Subject: Perry Nuclear Power Plant (Units 1 and 2) Conformance
with Regulatory Guide 1.114

Perry Nuclear Power Plant
Docket Nos. 50-440; 50-441
"Operator at the Controls"

Figure 13.5-1

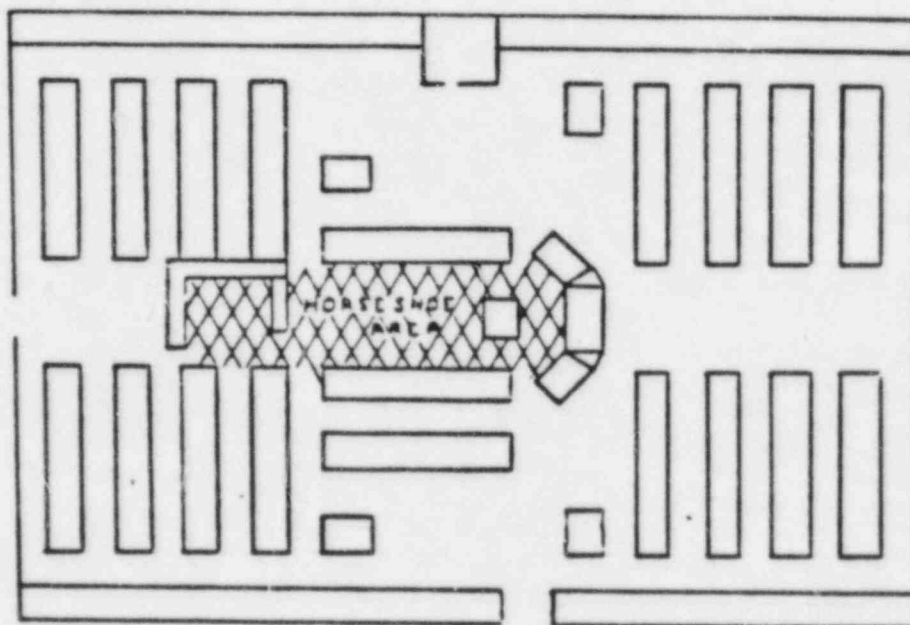
Your letter dated July 31, 1985, copy enclosed, proposed a change to Section 13.5 of the FSAR, redefining the area identified as the "operator at the controls area." The staff has reviewed the proposed change and finds it acceptable.

1. Standing orders to operations shift supervisors and personnel including proper shift relief and turnover procedures.
2. Authority and responsibilities of reactor operators and senior reactor operators including succession in the control room.
3. Responsibility to meet licensed operator requirements as described in 10CFR50.54(i), (j), (k), (l) and (m). The area "at the controls" as discussed in the above articles of 10CFR50.54 and in the guidance in Regulatory Guide 1.114, is as shown in Figure 13.5-1 (horseshoe area).

replace Fig. 13.5-1
with figure on
next page

Area Designated as "At the
Controls" (Unit 1 shown-
Unit 2 similar)
